# Trees and Construction

## BS5837 Tree Survey, AIA & AMS

**Site:** 15 Wedderburn Road, London, NW3 5QS

**Ref:** 17238 / A2\_AIA\_Rev.A

**Proposed scheme overlay for review ref: 276\_004\_P3**

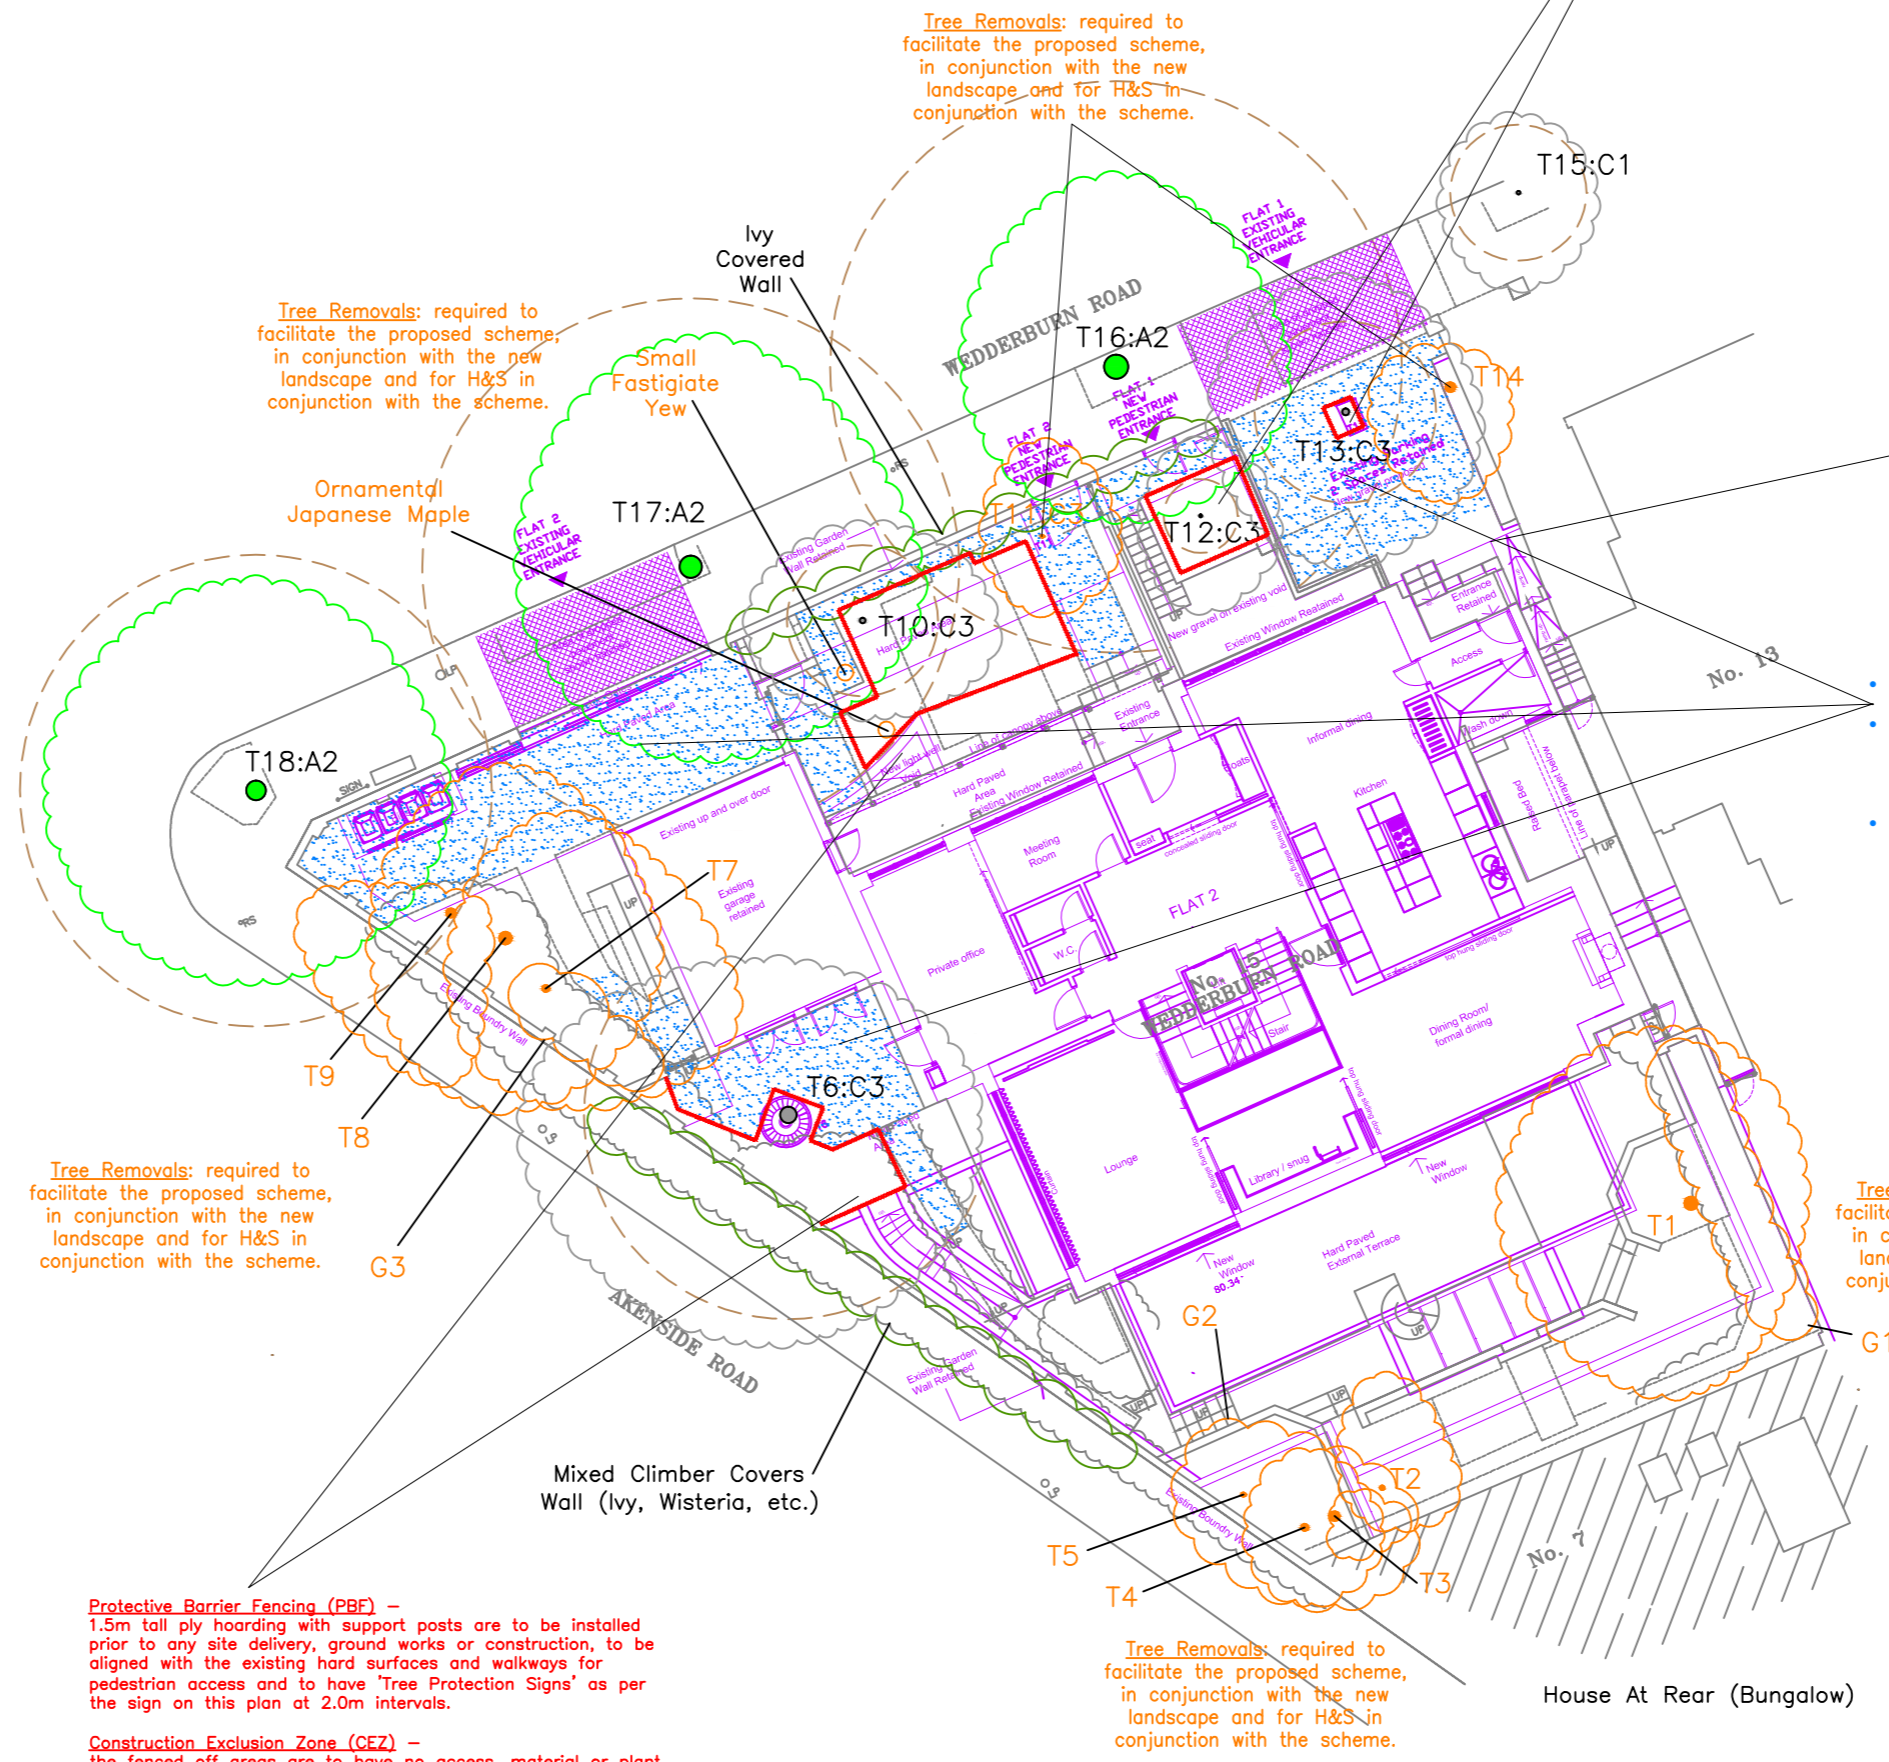
- NOTE: The scheme shows the rear extension, landscape levels and retaining wall design to the rear in and around T1. Due to the anticipated tree root impact and crown conflict, the removal of T1 is recommended with replacement by 1x small / medium scale larger nursery stock tree, or 2-3x small trees would be suitable within the design. Further, the removal of G1 and T8 are included and it is recommended that a soft landscape section is utilised alongside the Akenside Road boundary for enhancement tree planting.

NOTE: The RPAs of T6 and T16 - T18 cover the largest proportion of the site, and T10, T12 and T13 within the front garden and driveway. On this basis, and knowing of possible root growth influences, it is recommended that the existing soil levels are retained and protected within the RPAs unless confirmed otherwise by monitored and recorded tree root investigations, i.e. the landscape works need to account for RPAs by design.

NOTE: The hard surface works within the RPA of retained trees (T6, T10, T12, T13, T16 - T18) require sensitive methods and retained soil levels to ensure no change of circumstance for said trees. If a greater extent of works are proposed within these areas, more specific advice should be sought from a qualified arboriculturalist with a view to assessing the feasibility of said proposal and forming a suitable method statement.

NOTE: The scheme accounts for the above advice whereby the retained hard surface entrance and garden area will have the levels maintained and works undertaken sensitively within the RPAs of retained trees: T6, T10, T12, T13, T16 - T18.

NOTE: The proposed scheme only requires the removal of poor quality trees (T2 - T5, G2 and T14) and low quality trees (T1, T7 - T9 and T11).
